TO: Zoning Committee

FROM: Bill Dermody, City Planner

SUBJECT: 1179 7<sup>th</sup> Street East CUP

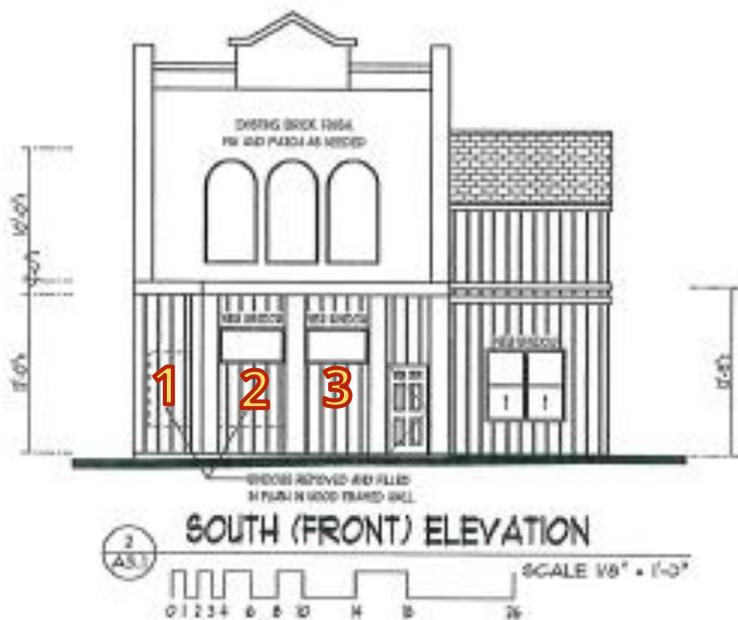
1. The recently constructed southwest corner wall on the first floor would need to be removed and replaced with an angled doorway entrance that faces both streets.
2. East of that, a storefront-style window would need to replace a piano window between the columns.
3. East of that, another storefront-style window would need to replace a piano window between the next set of columns.

Note that the window opening along Duluth Street near the corner, which appears as a piano window-style opening in the photo above, is no longer an issue – it has been replaced with a larger window opening since this photo was taken, and will have a sufficiently sized window to meet the recommended condition.

According to the applicant, Design Element #1 and Design Element #3 would be major hardships to comply with the recommended condition, for several reasons:

The applicant believes he could abide by the recommended condition with regard to Design Element #2 without major hardship, by relocating a larger window currently slated for the east façade to the front façade.

The staff recommendation has not changed. All completed construction was done without formal permits and was therefore done "at risk". The unit's great room could reasonably be swapped with the bedroom and bathroom to facilitate the recommended exterior changes, as described in the staff report.

1. The elements of traditional storefront design in the building, including ~~a primary entrance at the SW corner of the building facing both E 7<sup>th</sup> Street and Duluth Street, the historic storefront window openings facing both public streets,~~ the historic vertical brick piers in the front facade, ~~and~~ the intermediate cornice over the storefront, the historic storefront window opening facing Duluth Street near the corner, and one of the historic storefront window openings facing E 7<sup>th</sup> Street, must be retained.
